UNITED STATES PATENT AND TRADEMARK OFFICE

APPLICATION NO.	FILING DATE	FIRST NAMED INVENTOR	ATTORNEY DOCKET NO.	CONFIRMATION NO.
10/752,284	01/05/2004	Yeung Kai Wah Mason	260-003	3411

Office Action Summary	Application No. 10/752,284	Applicant(s) MASON, YEUNG KAI WAH	
	Examiner Philip Gabler	Art Unit 3637

Exhibit 1: Monneret '573 Figures 1 and 2

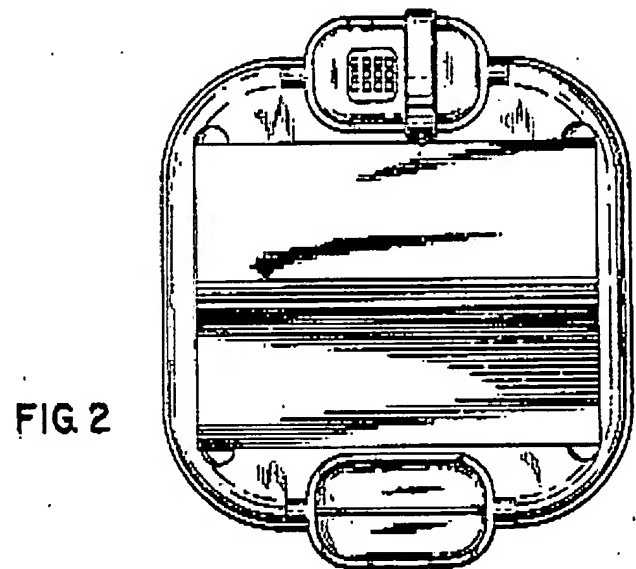
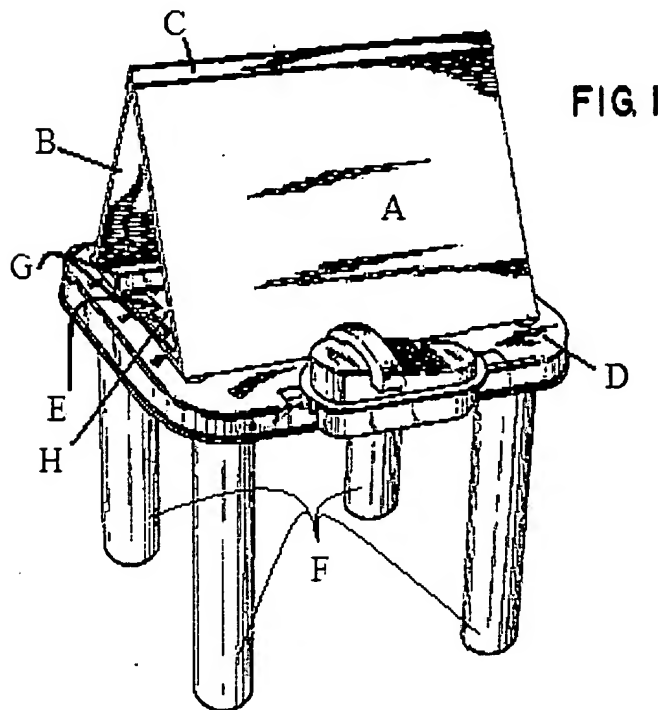
14. Claims 17, 21, 22, 26, 32, and 33 are rejected under 35 U.S.C. 102(b) as being anticipated by Monneret (US Patent Number D330573). Monneret (Figures 1 and 2) discloses a desk comprising an upper surface (viewed as A and B in Exhibit 1), wherein said upper surface is further comprised of a first surface (A) made of a first material and having a first edge, a second edge, a third edge and a fourth edge, a second surface (B) made of a second material (the first and second materials are not specifically

disclosed, and may or may not be the same material) and having a first edge, a second edge, a third edge and a fourth edge, wherein said first edge of first surface being attached to said first edge of said second surface by a hinged mechanism (C); a frame (D) comprised of a rectangular surface having a substantially rectangular concentric hole (E), top, bottom, a first inner edge, first outer edge, second inner edge, second outer edge, third inner edge, third outer edge, fourth inner edge and fourth outer edge; four support members (F), wherein each said support member has a first and a second end and each said first end of each said member is in contact with the ground and each said second end of each said member is in contact with said frame; and at least two cross members (rails under unhinged edges of surfaces seen in Figure 1, G), each of said members having a first end, a second end, an inner surface, a top end and a bottom end, wherein each said first end and each said second end of each said cross member is connected to said bottom of said frame and capable of supporting the weight of said upper surface.

15. Regarding claim 21, Monneret further discloses said at least two cross members are positioned substantially parallel with each other and with said second inner edge.

16. Regarding claim 22, Monneret further discloses said support members connect to said bottom of said frame near the intersection of two connecting inner edges of said frame.

17. Regarding claim 26, Monneret further discloses a lower surface (H) attached to the bottom end of each cross member to provide a storage compartment contained within said frame and covered by said upper surface.

18. Regarding claims 32 and 33, Monneret further discloses said four support members are connected perpendicularly to said frame (and accordingly at an angle between 90 and 145 degrees).

Tsai '939 Figures 2, 4, 13, and 17

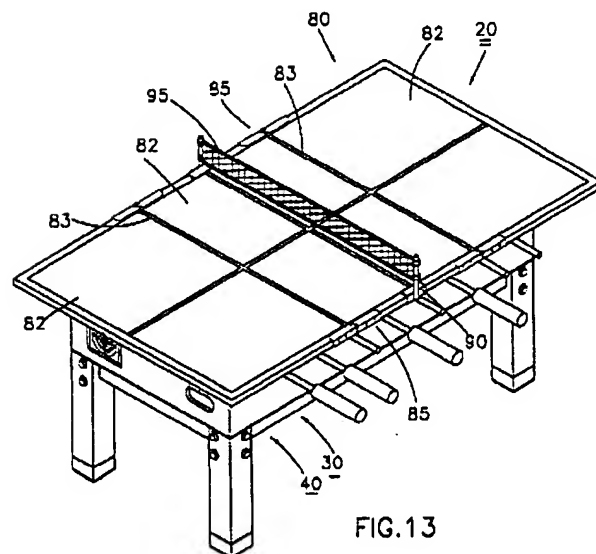
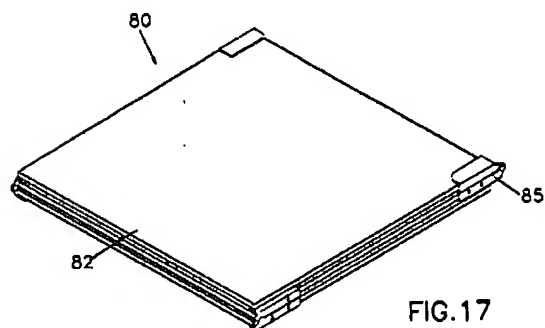
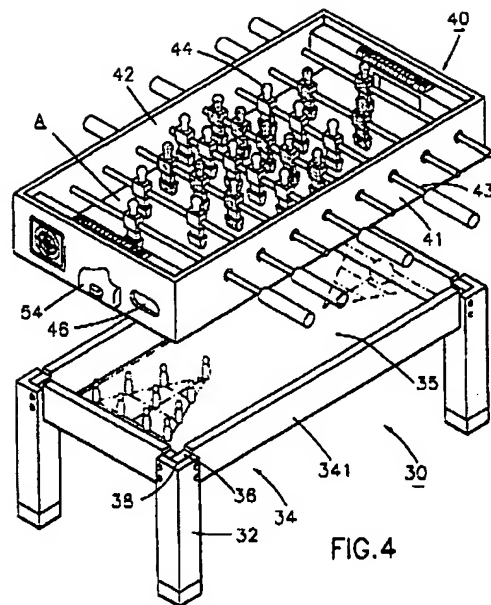
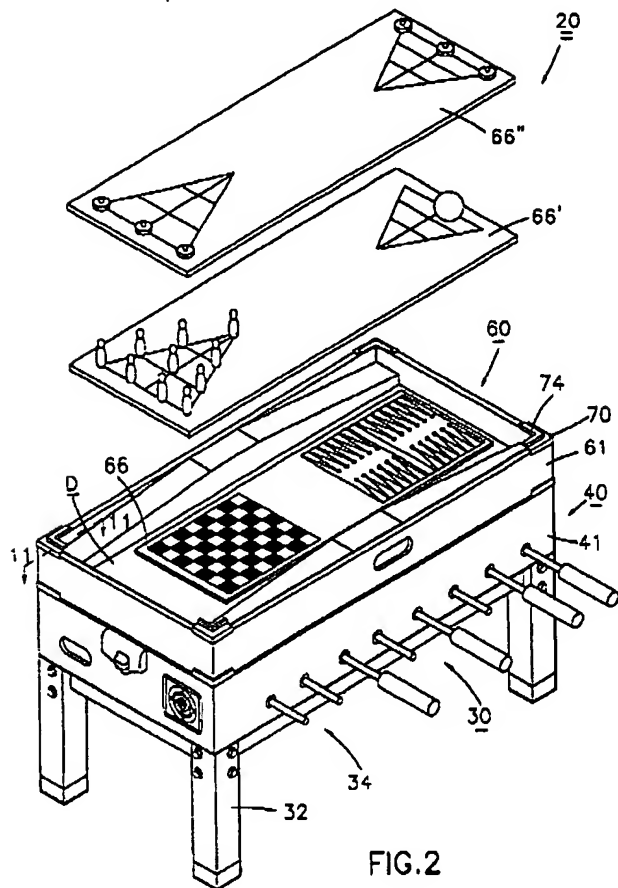
20. Regarding claims 17 and 34, Tsai (Figures 2, 4, 13, and 17) discloses a table usable as a desk comprising an upper surface (80), wherein said upper surface is further comprised of a first surface (leftmost element 82 as seen in Figure 13) made of a first material and having a first edge, a second edge, a third edge and a fourth edge, a

second surface (rightmost element 82 as seen in Figure 13) made of a second material (the first and second materials are not specifically disclosed, and may or may not be the same material) and having a first edge, a second edge, a third edge and a fourth edge, wherein said first edge of first surface being attached to said first edge of said second surface by a hinged mechanism (middle element 82 as well as elements 85); a frame (of elements 40, 60) comprised of a rectangular surface having a substantially rectangular concentric hole (in the center of the assembly, formed by the walls of 40, 60), top, bottom, a first inner edge, first outer edge, second inner edge, second outer edge, third inner edge, third outer edge, fourth inner edge and fourth outer edge; four support members (32), wherein each said support member has a first and a second end and each said first end of each said member is in contact with the ground and each said second end of each said member is in contact with said frame; at least one storage tray (viewed as the lower horizontal surface of 40) removably contained below said frame; and at least two cross members (two rails formed on the inside of element 60, see Figure 2), each of said members having a first end, a second end, an inner surface, a top end and a bottom end, wherein each said first end and each said second end of each said cross member is connected to said bottom of said frame and capable of supporting the weight of said upper surface.

21. Regarding claim 21, Tsai further discloses said at least two cross members are positioned substantially parallel with each other and with said second inner edge.

22. Regarding claim 22, Tsai further discloses said support members connect to said bottom of said frame near the intersection of two connecting inner edges of said frame.

23. Regarding claims 23-25, Tsai further disclose decorative and gameboard designs (57, 66, lines on 80, etc.) on the frame and upper surface.

24. Regarding claim 26, Tsai further discloses a lower surface (lower horizontal surface of 40) attached to said bottom of said frame to provide a storage compartment contained within said frame and covered by said upper surface.

25. Regarding claim 27, Tsai further discloses at least one additional support member (341) having a first end and a second end, wherein said first end is connected to one of said four support members and said second end is connected to another of said four support members.

26. Regarding claim 30, Tsai further discloses at least one storage tray (viewed as the lower horizontal surface of 40) removably contained below said frame.

27. Regarding claims 32 and 33, Tsai further discloses said four support members are connected perpendicularly to said frame (and accordingly at an angle between 90 and 145 degrees).

Benlian '611 Figure 1

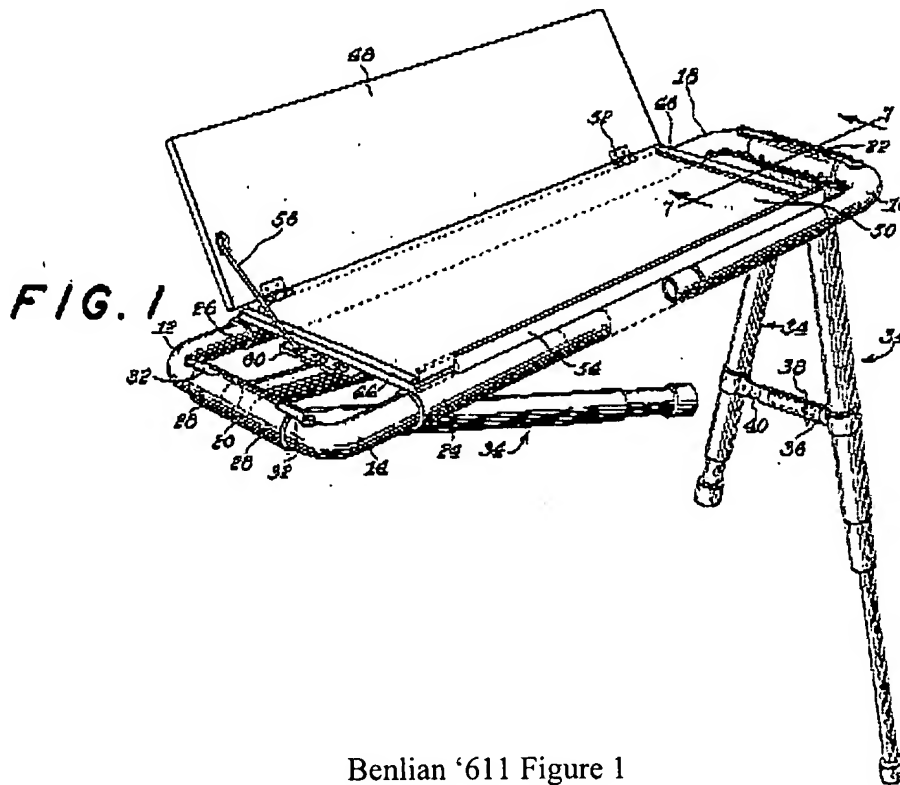
28. Claims 17, 21, 22, 28, 29, 32, and 33 are rejected under 35 U.S.C. 102(b) as being anticipated by Benlian (US Patent Number 3246611). Benlian (Figure 1) discloses a desk comprising an upper surface (48, 50), wherein said upper surface is

further comprised of a first surface (48) made of a first material and having a first edge, a second edge, a third edge and a fourth edge, a second surface (50) made of a second material (the first and second materials are not specifically disclosed, and may or may not be the same material) and having a first edge, a second edge, a third edge and a fourth edge, wherein said first edge of first surface being attached to said first edge of said second surface by a hinged mechanism (at 52); a frame (12, 14, 16, 18, 20, 22, etc.) comprised of a rectangular surface having a substantially rectangular concentric hole (formed by the frame members), top, bottom, a first inner edge, first outer edge, second inner edge, second outer edge, third inner edge, third outer edge, fourth inner edge and fourth outer edge; four support members (34), wherein each said support member has a first and a second end and each said first end of each said member is in contact with the ground and each said second end of each said member is in contact with said frame; and at least two cross members (44, 46), each of said members having a first end, a second end, an inner surface, a top end and a bottom end, wherein each said first end and each said second end of each said cross member is connected to said bottom of said frame (via members 24, 26) and capable of supporting the weight of said upper surface.

29. Regarding claim 21, Benlian further discloses said at least two cross members are positioned substantially parallel with each other and with said second inner edge.

30. Regarding claim 22, Benlian further discloses said support members connect to said bottom of said frame near the intersection of two connecting inner edges of said frame.

31. Regarding claim 28, Benlian further discloses each of said four support members is hingedly attached to said frame.

32. Regarding claim 29, Benlian further discloses said second inner edge of said frame and fourth inner edge of said frame have a recessed opening (outside of members 44 and 46) protruding through both said top and bottom of said frame.

33. Regarding claims 32 and 33, Benlian further discloses said four support members are connected perpendicularly (at least in one plane) to said frame (and accordingly at an angle between 90 and 145 degrees).

Hackwood '271 Figure 2

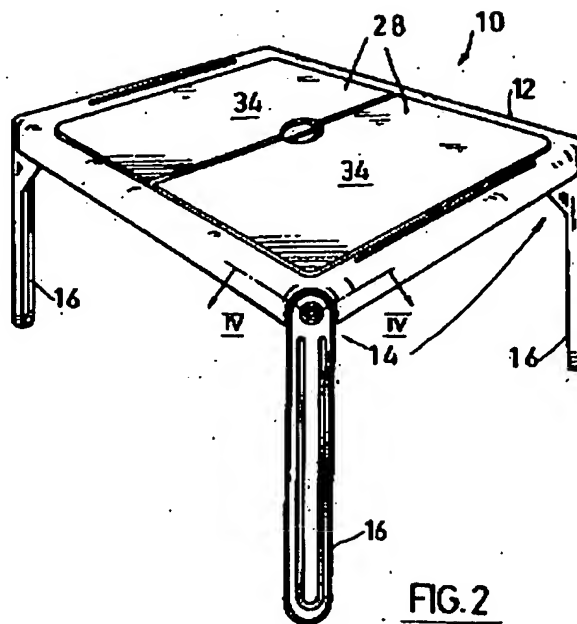
35. Claims 18 and 19 are rejected under 35 U.S.C. 103(a) as being unpatentable over Benlian in view of Hackwood et al. (US Patent Number 5244271). Benlian discloses a desk as recited in claim 17 but does not disclose a material for his first and second surfaces. Hackwood (Figure 2) discloses a desk with first and second surfaces (28) selected from the group consisting of blackboard, whiteboard, slate, dry erase or corkboard (specifically blackboard and whiteboard, see column 5 lines 4-11). Accordingly, it would have been obvious to one of ordinary skill in the art at the time the invention was made to use blackboard or whiteboard for Benlian's first and second surfaces as taught by Hackwood because this would allow the surfaces of the desk to be used for writing and conveying information directly.

Cheng '929 Figure 5

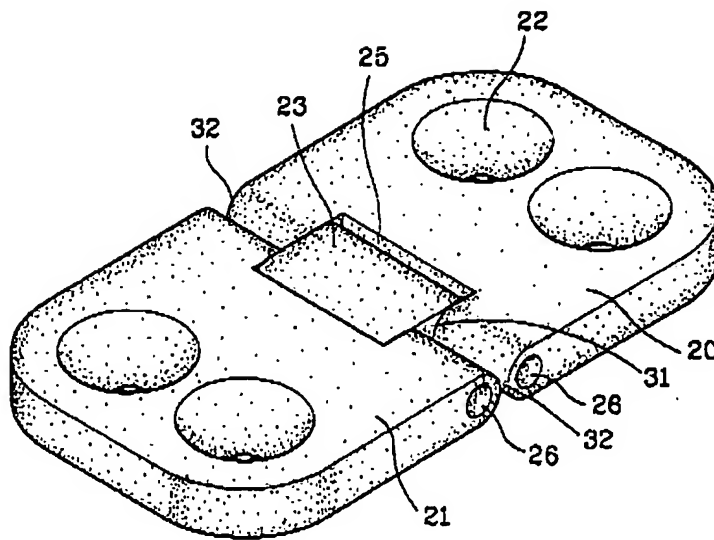
36. Claim 20 is rejected under 35 U.S.C. 103(a) as being unpatentable over Monneret in view of Cheng (US Patent Number 5659929). Monneret discloses a desk as recited in claim 17 but does not disclose specifics of his hinge mechanism. Hinge mechanisms capable of 360 degree rotation are known in the art however, as shown by Cheng who (Figure 5) discloses such a mechanism. Accordingly, it would have been obvious to one of ordinary skill in the art at the time the invention was made to incorporate a hinge mechanism as taught by Cheng in Monneret's desk because it would allow a user to set the two surfaces at any angle relative to each other as desired.

Brenny '639 Figure 1 and 5

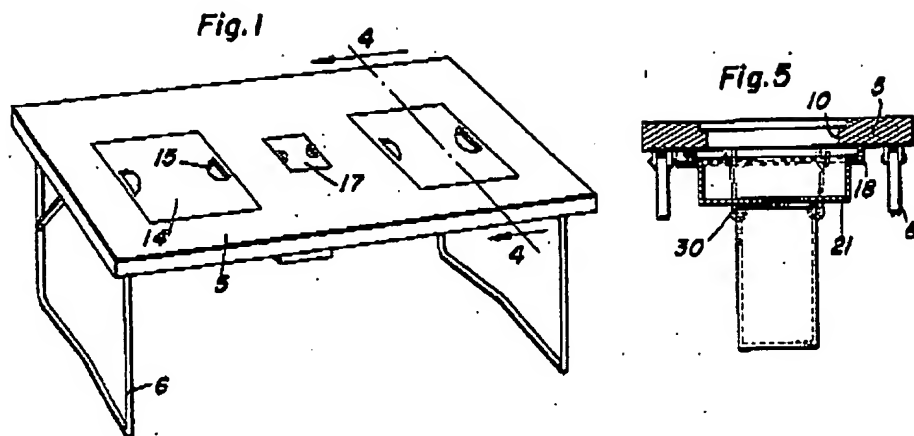
37. Claims 30 and 31 are rejected under 35 U.S.C. 103(a) as being unpatentable over Benlian in view of Brenny (US Patent Number 2683639). Benlian discloses a desk as recited in claim 17 including substantially parallel cross members, but does not disclose a storage tray below his frame. Brenny (Figures 1 and 5) discloses a table/desk including a storage tray (21) removably contained below a frame with substantially parallel cross members (opposite arms 18) comprising a protruding ridge (19) along inner surfaces which allow for the receipt of the at least one storage tray. Accordingly, it would have been obvious to one of ordinary skill in the art at the time the invention was made to include a storage tray as taught by Brenny in Benlian's desk because of the extra storage such a tray could provide.
